Advisory Action

09/930,007

OTTER, JAMES WILLIAM

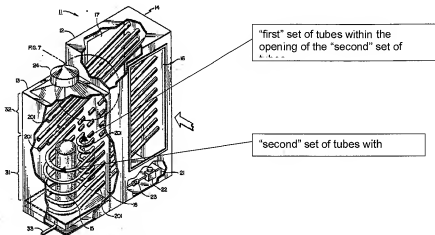
Applicant argues on page 8 that in reference to claims 24-27, it is not possible to locate a straight pipe between the U-shaped pipes of Ripka, that the u-shaped pipes are u-shaped in order to accommodate radiant burner 15. The claims do not require a straight pipe between a u-shaped pipe. Claim 24 only requires "a first expanded tube and a second u-shaped expanded tube having a pair of ends and an opening defined between the pair of ends, said u-shaped expanded tube is continuous between said pair of ends, and said first tube is located in said opening". Ripka fully meets the limitations of a first tube within the opening of a U-shaped tube. In figure 2 of Ripka, it is clear that a set of "first" tubes, which happen to also be u-shaped (the claims do not exclude u-shaped first tubes), are located within the openings of a set of "second" u-shaped tubes. Please see the attached drawing below.

Applicant further argues on page 8 in reference to claims 5, 6, 10 and 11 that it is not possible to position a straight pipe between the u-shaped pipe of Ripka due to the presence of radiant burner 15. The claims do not require a straight pipe between a u-shaped pipe. As discussed above, the references fully meet the limitations of the claims. Ripka does disclose a "first" tube within the opening of a "second" u-shaped tube. See the discussion above.
